SHOP DRAWING REVIEW

WORK: NETC 4 RAIL-BRIDGE RAILING
 VT. ROUTE 78 OVER MISSISQUOI BAY
 ALBURG - SWANTON, VERMONT

DRAWING: BRIDGE RAIL TUBE SPLICE DETAILS

B4 ~ 4 REQ'D

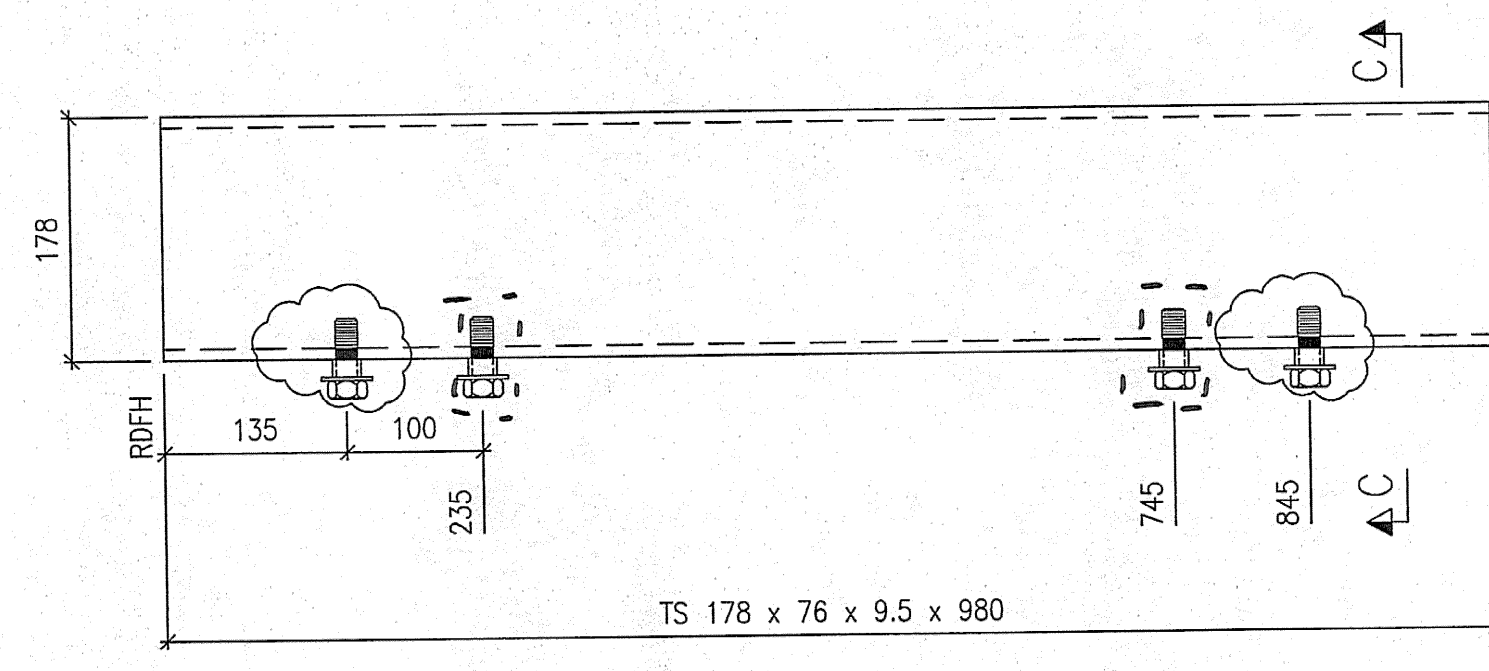
HOWEVER, BACKING NUTS REMOVED AT THESE LOCATIONS TYP.

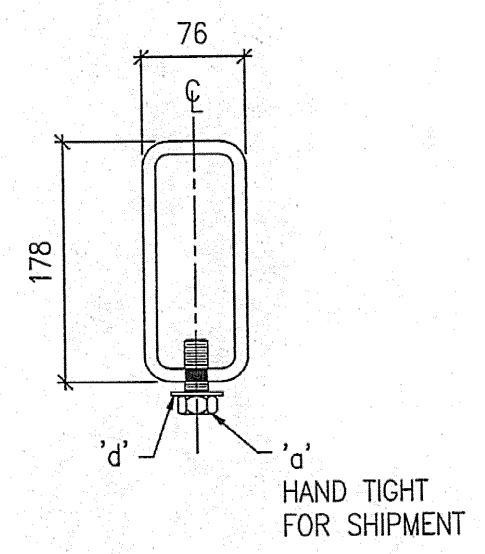
ADD BACKER NUTS + TACK WELD DETAIL TO SECTIONS + BILL OF MAT'L LIST
